MAINE TURNPIKE AUTHORITY

ADDENDUM NO. 2

CONTRACT 2015.11

WEST GARDINER BARRIER TOLL PLAZA
OPEN ROAD TOLLING CONVERSION
MILE 100.2

MAINE TURNPIKE AUTHORITY
DRILLED SHAFT ALTERNATE
WITH 2'-0" DIA. ROCK SOCKET

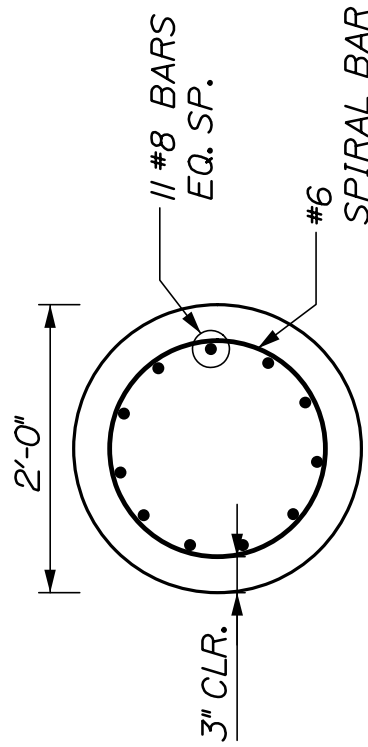
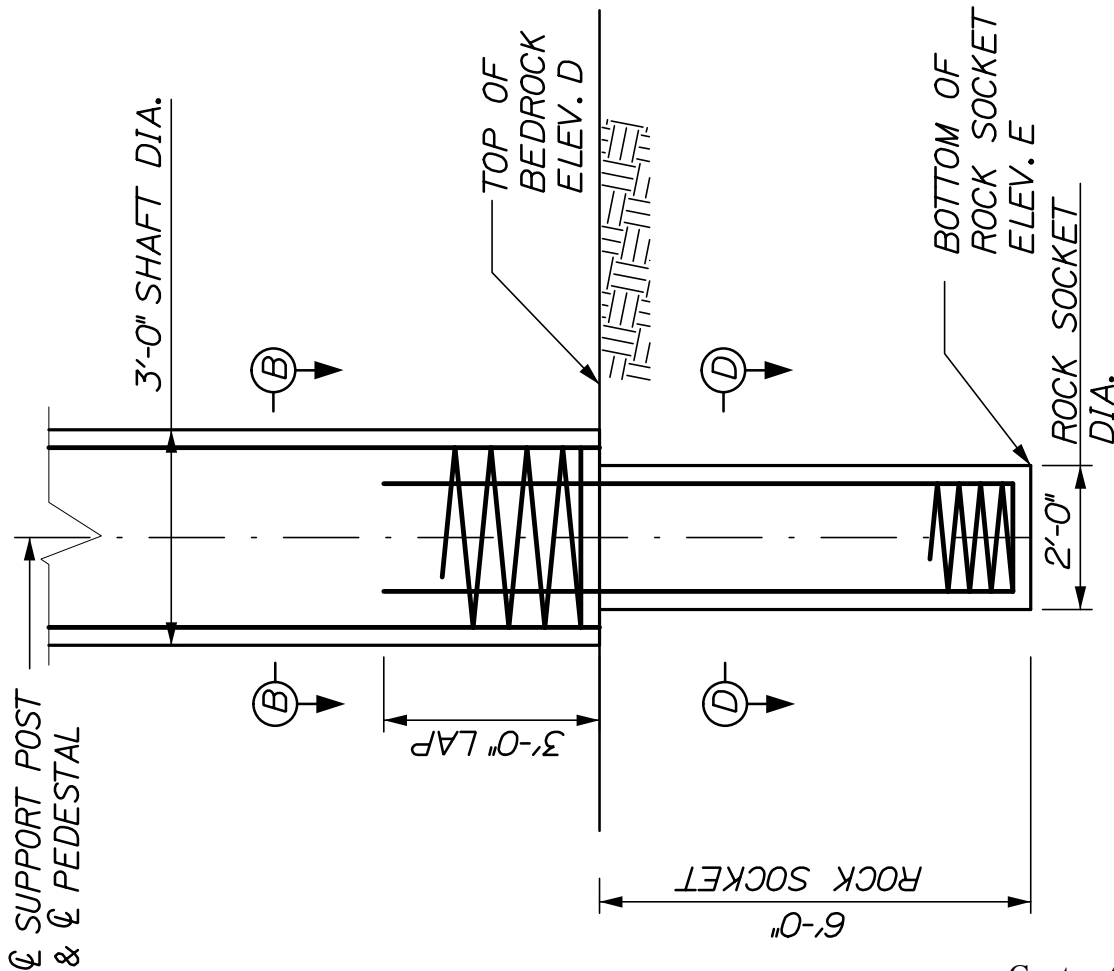
Question 3: Can a 24 inch rock socket be used in place of a 36 inch rock socket within the 36 inch drilled shaft?

Answer: Yes, a 24 inch rock socket is acceptable following the attached alternate detail Figure 1 for the Structure Foundation on S-09 sheet 84 of 118.

WEST GARDINER BARRIER TOLL PLAZA
ORT CONVERSION Contract 2015.11
ORT SLAB PLAN Addendum No. 2
Page 6 of 7

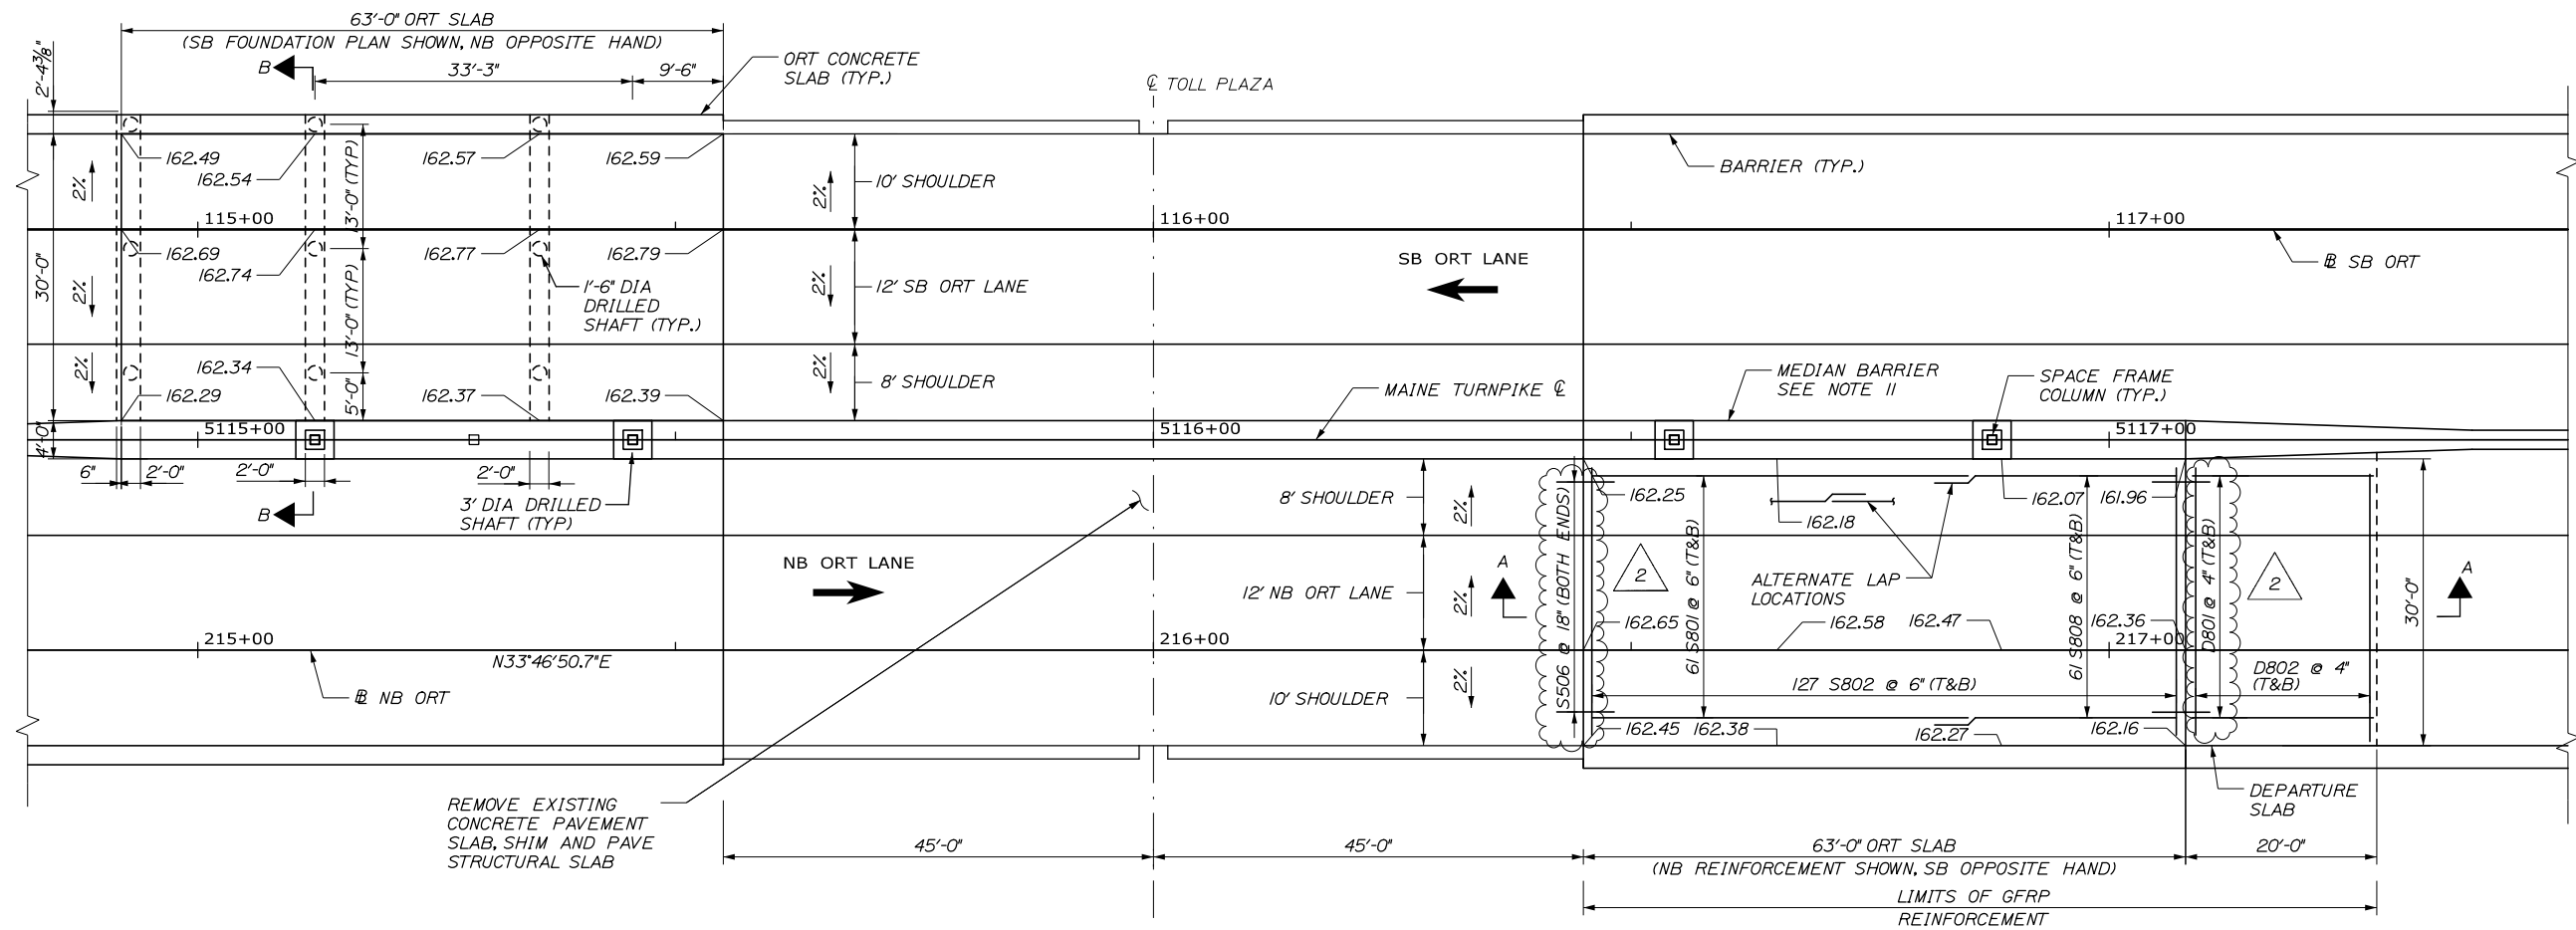
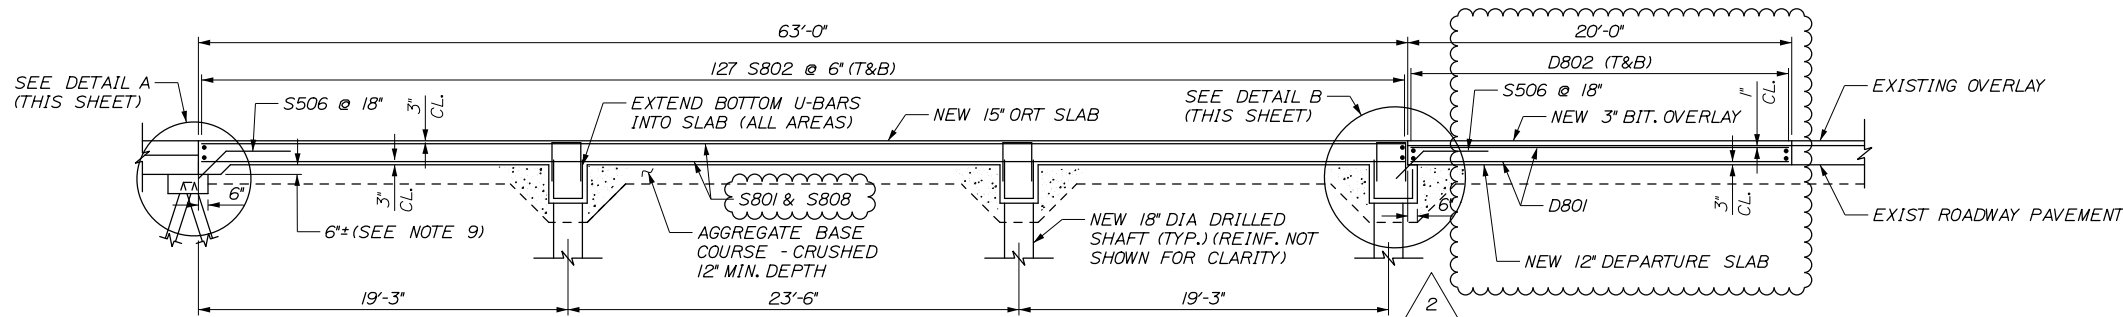
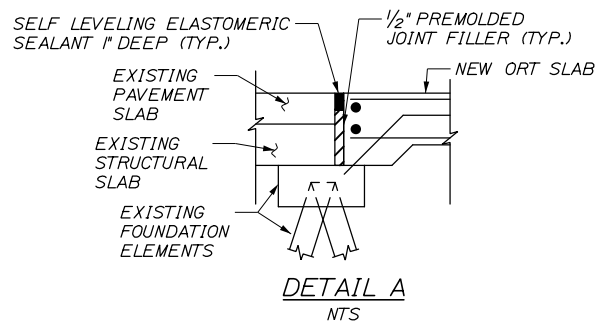
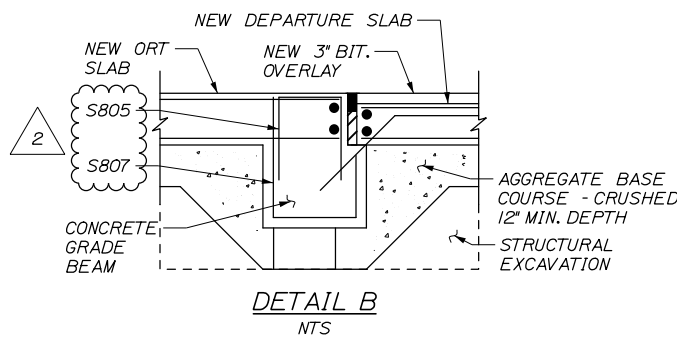
No.	Revision	By	Date
2	ADDENDUM #2 - REBAR MOD.	GLS	3/15

WEST GARDINER BARRIER TOLL PLAZA
 ORT CONVERSION
 ORT SLAB FOUNDATION DETAILS
 Contract 2015.11
 Addendum No. 2
 Page 7 of 7
 SHEET NUMBER: S-17
 CONTRACT:-
 92 OF 118

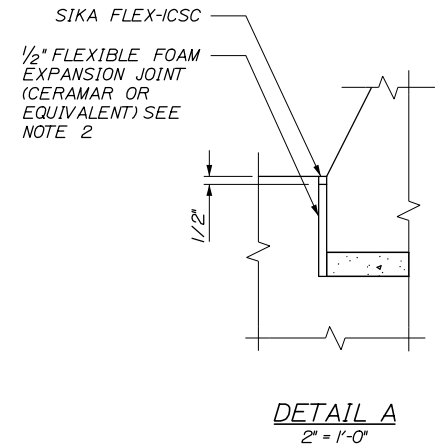
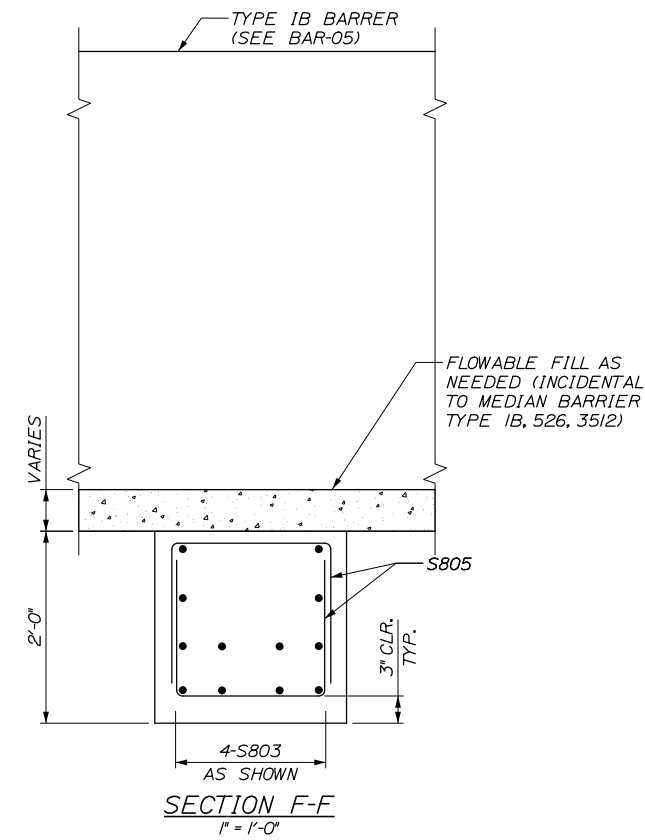
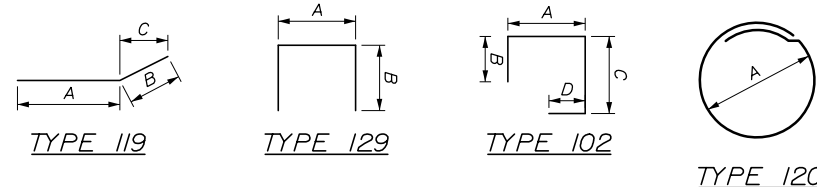
Scale: AS NOTED			
No.	Revision	By	Date
2	ADDENDUM #2 - REBAR MOD.	AJF	3/15
